Re: Stormwater Management **CONCEPT** Request
for Herb Gordon Auto World
SM File #: 211742
Tract Size/Zone: 5.06 acres / C3
Total Concept Area: 5.06 acres
Parcel(s): N970
Watershed: Little Paint Branch

DATE: 1-24-06
TO: PLANNING BOARD, MONTGOMERY COUNTY
VIA:
FROM: CAPTAIN JOHN FEISSNER 240.777.2436
RE: APPROVAL OF ~ *MONTGOMERY AUTO SALES PARK PLAN #8-06001 & 8-06002/SITE PLAN DATED AUGUST, 05*

Re: Montgomery County
Intercounty Connector
Montgomery Auto Sales Park (8-06001 & 8-06002)

SUBJECT: Preliminary Plan 120041010 and Site Plan Number 820060010,
Montgomery Auto Sales Park, Lot 17

CORRIDOR 1
 CHECK IMPACTS TO
 MONTGOMERY AUTO
 SALES PARK REDEVELOPMENT
 INTERCOURTY
 CONNECTOR
 ICC
 November 14, 2005 Study
 SCALE IN FEET
 0 25 50 100
 —: FOR ILLUSTRATIVE PURPOSES ONLY :—
 SOURCE: MARYLAND SHA (JAN 2006)

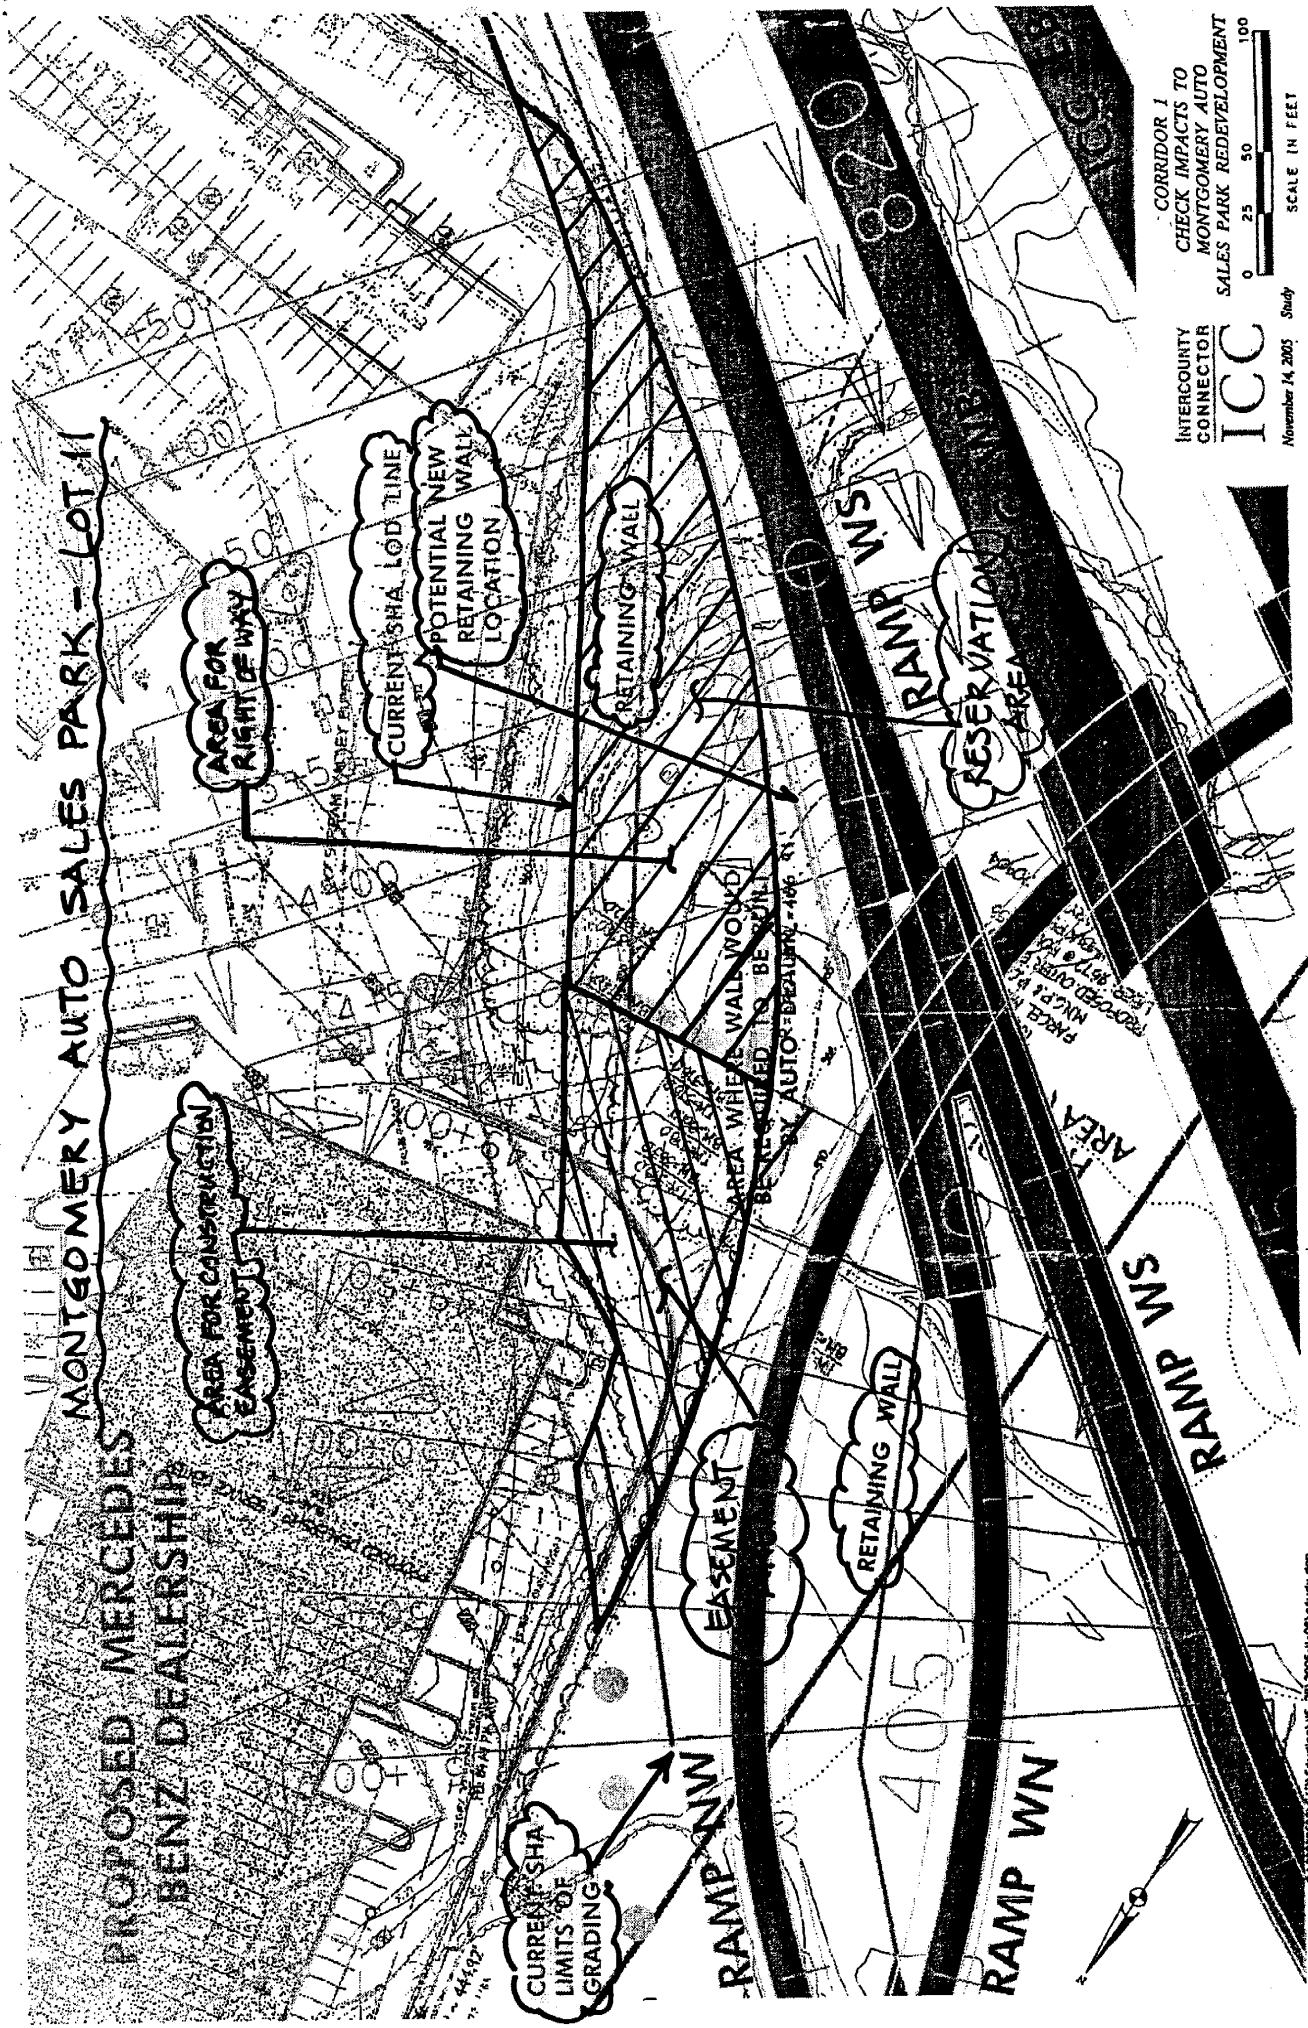
The Intercounty Connector (ICC) Corridor One, as shown to date, impacts about 0.80 acres of the property, as shown on the attached map. About 0.29 acres of this impact (highlighted in purple on the attached map), located right station 48+50 to right station 50+55 along ramp "NW", is due only to grading for supporting slopes, and could be handled as an easement. The remaining 0.51 acres of impact (highlighted in orange on the attached map) contains a potential retaining wall, and needs to be acquired as right-of-way.
